Three-Terminal Current and Voltage Regulators Are Supplied for Service Use on Previous Models

THE SIX-TERMINAL current and voltage regulator originally installed on 35-50, 36-Series and 37-70, 75, 85, 90 and 38-75, 90-Series Cadillac and La Salle cars is not furnished for service replacement. Instead, a special three-terminal regulator unit has been supplied.

The changes in connections required when installing replacement regulator 1886970 are shown at the left; those required when installing regulator 005817 are shown at the right.

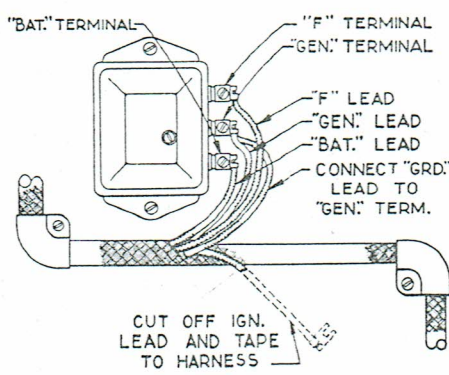
Effective immediately, this replacement regulator will be supplied in an assembly which includes the mounting bracket. Use of this bracket permits mounting the regulator unit with the same attaching screws in the same drilled holes as the original unit.

The regulator and bracket assembly carries Part No. 1886970 and a list price of \$7.15. It will be supplied on all orders for 005559, 005818, 005831, the original six-terminal regulators, or for 1118230, the replacement regulator unit.

Mounting the new regulator unit on the dash presents no problem, as the same screws and mounting holes are used, but it is important that the connections be made exactly as indicated in the illustration (at left below).

Connect the "F" lead to the "F" terminal, the battery lead to the battery terminal, and the generator lead to the generator terminal. Also connect the "R" (starting relay) lead to the generator terminal.

Cut off the ignition lead close to the harness opening and tape end of wire to harness. Lastly, install terminal of ground lead under one of the regulator bracket mounting screws, cleaning off any paint or corrosion to insure a good ground.

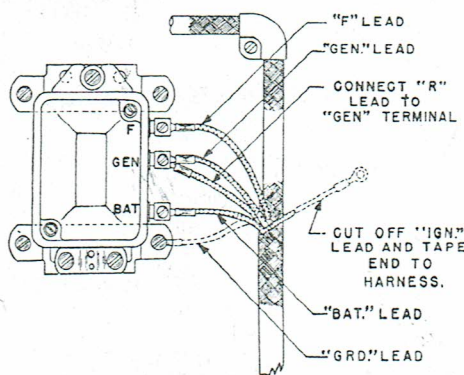
A different three-terminal regulator is also supplied for service use on those 37-50, 60, 65 and 38-50, 60, 60S, 65-Series cars on which a five-terminal voltage regulator, Part No. 005817, was used as original equipment.

This replacement regulator carries Part No. 005860, and a list price of

\$3.90. No special mounting bracket or attaching parts are required, as the new regulator uses the same screws and the same mounting holes as the original one.

In connecting the replacement regulator, follow the illustration at the right below. Connect "F", generator, and battery leads to the corresponding terminals; connect ground lead to generator terminal also; and cut off ignition lead at harness opening and tape to harness.
